Technical product information

Topic	1.5 KHz Front brake squeal when reversing
Market area	Bentley: worldwide (2WBE),Hongkong-Macau (5HK)
Brand	Bentley
Transaction No.	2053914/10
Level	EH
Status	Approval
Release date

New Continental GT/GTC and New Flying Spur

1.5 KHz Front brake squeal when reversing

Figure 1

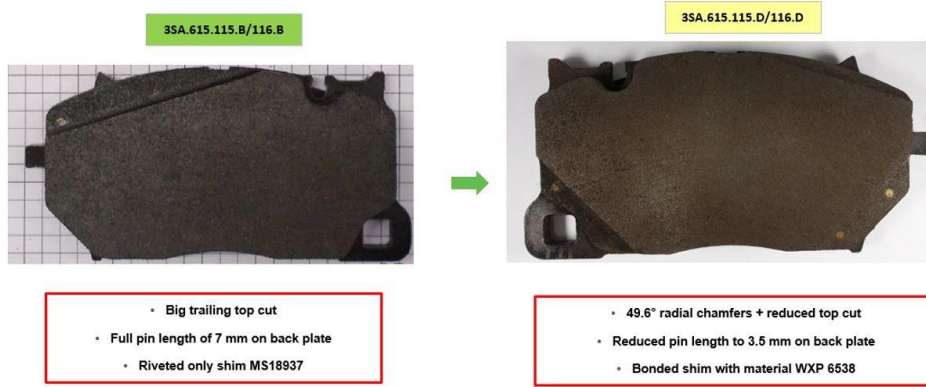
Figure 1 shows the previous and latest specification pads and a brief description of the differences between the two variants

Front brake pad service kit - 3SA698 151B or later will rectify the concern

Kit will include brake pad part numbers 3SA 615 115 D and 3SA 615 116 D or later (x2 each)
